HUNSAKER
& ASSOCIATES
IRVINE, INC.

January 20, 2025

Subject: **Conditional Use Permit No. 230002**
**Crescent Gardens Cemetery**
**Response to Comments**

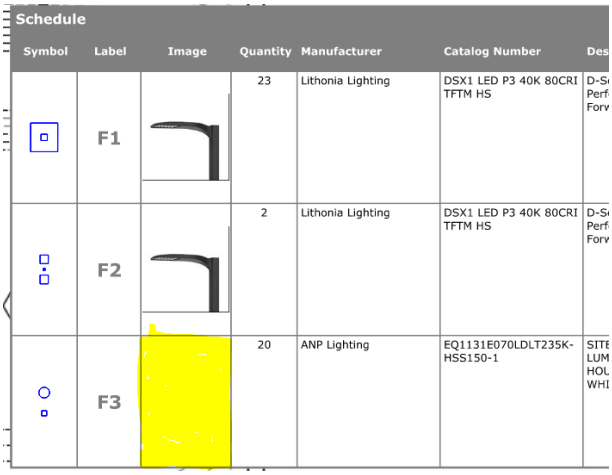
7. **Repeat Correction**: Provide a visual example of the F3 lighting proposed on-site so it can be verified that it's meeting lighting standards.
